LOCAL HISTORIC DISTRICT: Plaza Midwood

PROPERTY ADDRESS: 2101 The Plaza

SUMMARY OF REQUEST: Deck addition, door/window changes

HDC-2019-00351

REAR ELEVATION

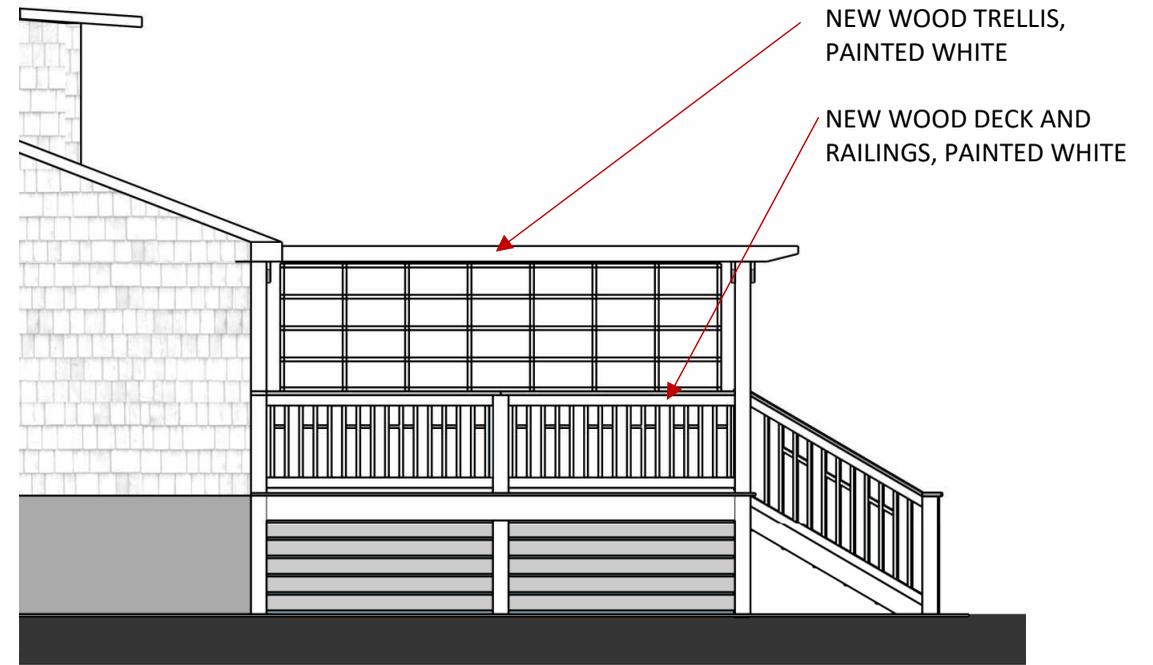
1. Staff would request that the applicant provide dimension information for the deck, rail, underpinning and trellis. Otherwise, the existing deck is a modern addition, and the replacement deck and trellis feature are not incongruous with the District and meets the guidelines for Additions, page 7.2.
2. The Commission will determine if the paired windows and the single window can be converted to door openings.
3. Minor revisions may be approved by staff.
